# Access Compliance Report

## Public Rights-of-Way

Intersection ID: 10039789	Main Street: TOLLESON_AV	Cross Street: N/A	Location: NW
ADA ID: 2D4BC38BC231	Ramp Type: PerpDiag	Initial Pass/Fail: Fail	Overall Compliance: No
Codes/Mitigation Info/Possible Solution		Field Measurements/Component Compliance	
Severity Score: 13.75

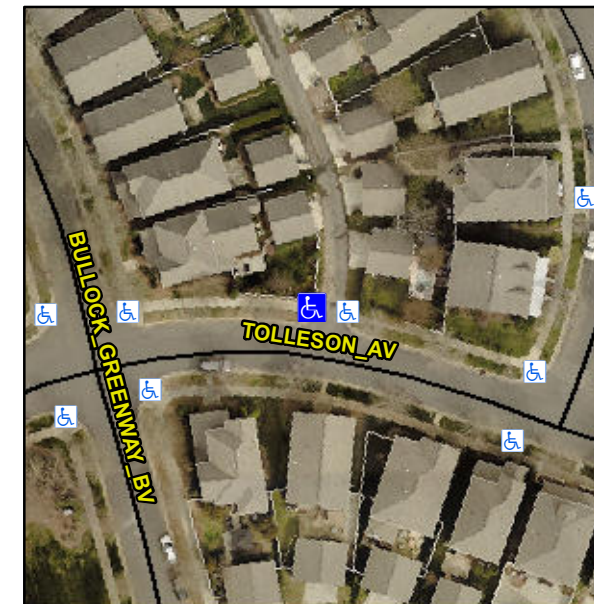
**Not Found, R304.2.2, R304.5.3**

Compliance	Description	Data	Compliance	Description	Data
N/A	Ramp Length (in)	106.0	No	Ramp Slope (%)	8.7
Yes	Ramp Width (in)	70.0	No	Ramp XSlope (%)	2.7
N/A	Flare Type LT	N/A	N/A	Flare Type RT	N/A
N/A	Flare Slope LT (%)	N/A	N/A	Flare Slope RT (%)	N/A
N/A	Flare Traversable LT?	N/A	N/A	Flare Traversable RT?	N/A
N/A	Landing Length (in)	N/A	N/A	DWS Provided?	N/A
N/A	Landing Width (in)	N/A	N/A	DWS Contrast?	N/A
N/A	Landing Slope (%)	N/A	N/A	DWS Length (in)	N/A
N/A	Landing X Slope (%)	N/A	N/A	DWS Full Width?	N/A
N/A	Landing Curb? (Y/N)	N/A	N/A	DWS Offset (in)	N/A
N/A	Shared Landing?	N/A			
N/A	Gutter Ponding?	N/A	N/A	Gutter Slope (%)	N/A
N/A	Gutter Lip Ht (in)	N/A	N/A	Gutter X Slope (%)	N/A
N/A	Painted X Walk1?	No	N/A	Painted X Walk2?	No
	X Walk 1 Direction	To S		X Walk 2 Direction	To E
N/A	X Walk 1 Width (in)	N/A	N/A	X Walk 2 Width (in)	N/A
	X Walk 1 Slope (%)	3.2		X Walk 2 Slope (%)	2.1
	X Walk 1 X Slope (%)	2.1		X Walk 2 X Slope (%)	1.9

**Remove & Replace Curb Ramp With Two New Directional Ramps or Equivalent.**
